On February 9, 2016 the City of Tualatin approved with conditions AR 15-0027 for Ruth T LLC Building #6 located at 12171 & 12225 SW Herman Rd (Tax Lot: 2S122C00602 & 606).

## ARCHITECTURAL REVIEW FINDINGS AND DECISION

Case #: AR-15-0027  
Project: Ruth T LLC Building #6  
Location: [12171 & 12225 SW Herman Rd.](#) (Tax Lots 2S1 22C 000602 & 000606)  
Applicant: Ruth T LLC; David Silvey, PO Box 205, Tualatin, OR 97062  
Project Contact: Silco Commercial Construction; Rory Antis, rantis@silco.info; 8316 N. Lombard #451, Portland, OR 97203. (503) 286-8691

**SITE LIGHTING PLAN**  
 SCALE: 1" = 20'

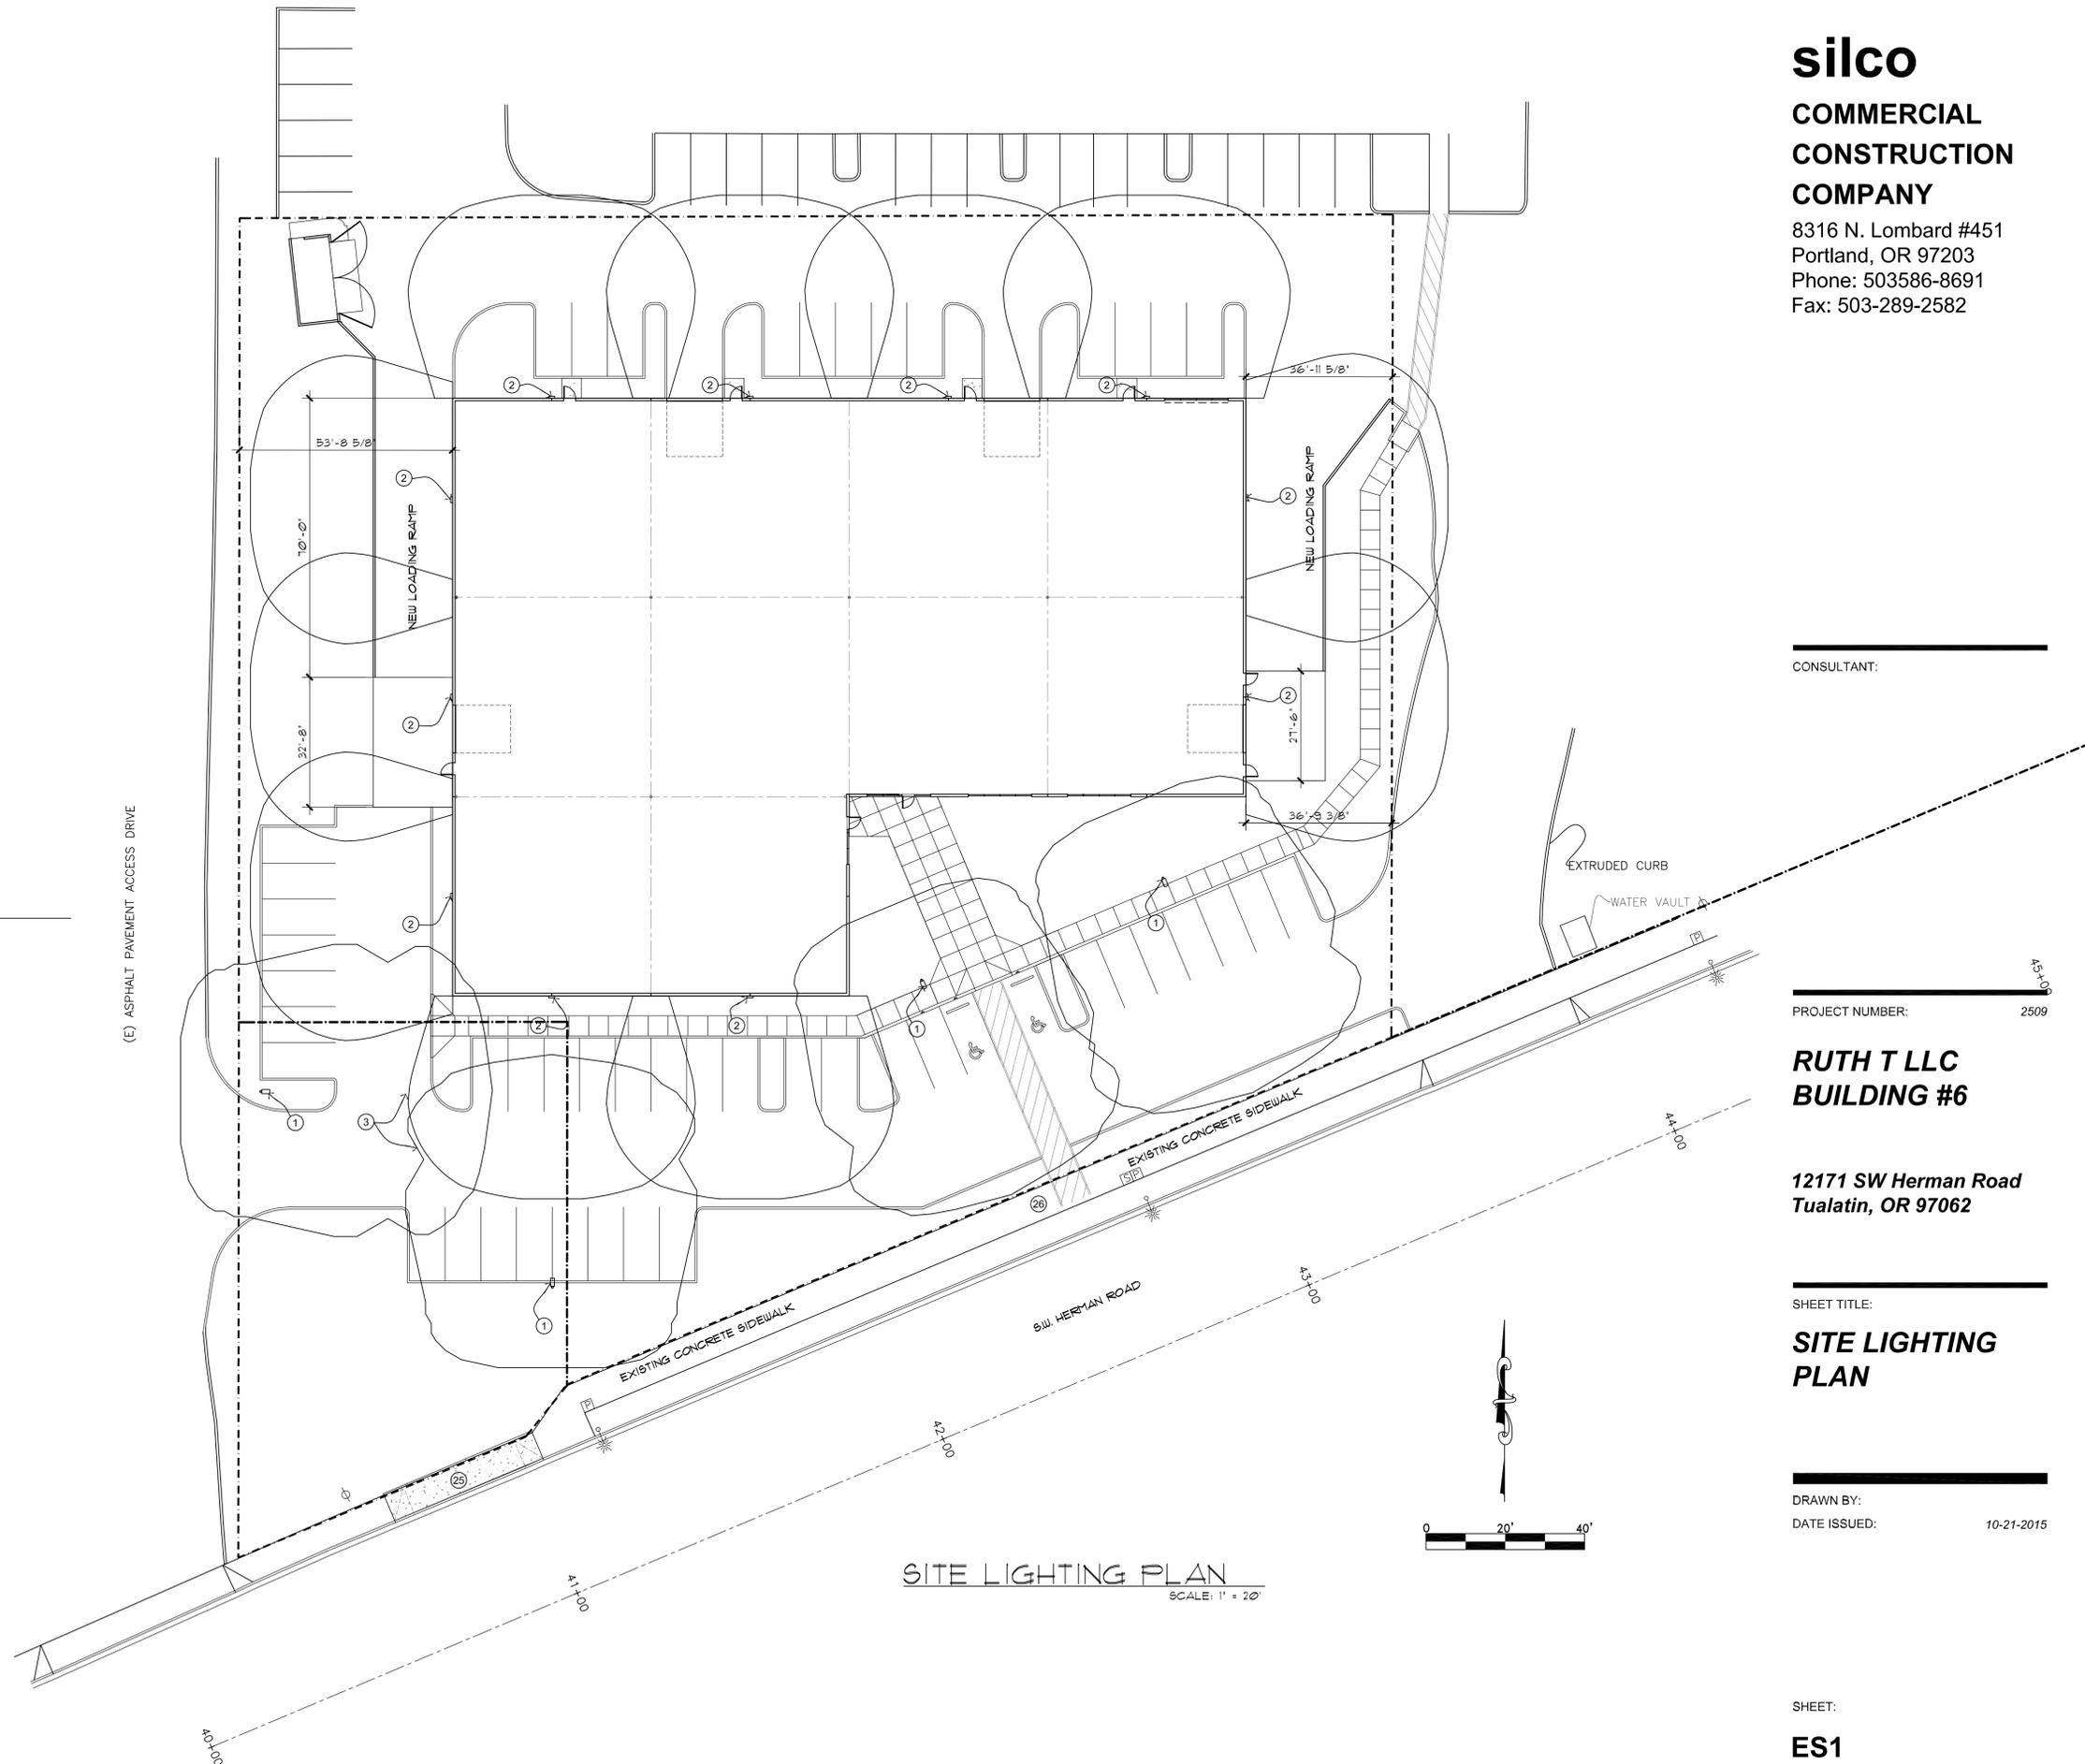
- AR-7 Revise plans to specify full-cut off or fully-shielded wall lights. 73.380(6)

Staff notes that the proposed lighting plan, Sheet ES1, indicates that the main entrance will be in shadow. The plans shall be revised with an appropriate solution to illuminate the main entrance.
